Countries: Document ID: IK1201270
 Availability: Revision: 1
 Major System: ENGINES Created: 2/25/2015
 Current Language: English Last Modified: 6/4/2015
 Other Languages: NONE Author: Alex Buzgau
 Viewed: 61

Title: Interstage Cooler Interference With Valve Cover Sound Shield Mounting Bolts

Applies To: EPA 2013 HD-OBD and later DT/9/10 and N9/N10

Figure 1: Interstage Cooler

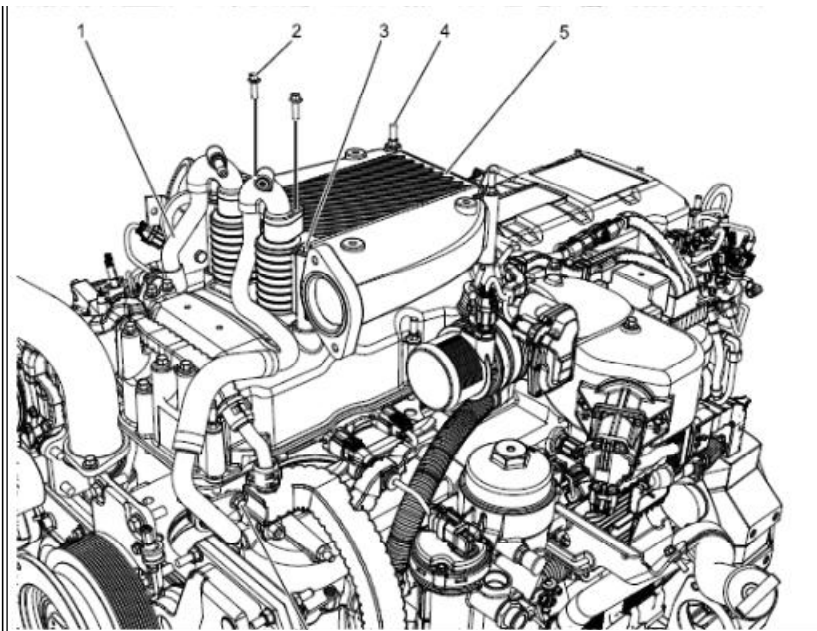
If contact between the bottom panel of the interstage cooler and the valve cover sound shield mounting bolt is observed, the current socket head screw could cause interference issues between itself and the interstage cooler.

To remedy this, the socket head screw must be replaced with a button head screw, which will provide an additional 2.25mm of clearance. Additionally, if the interstage cooler is punctured due to the interference then it also must be changed.
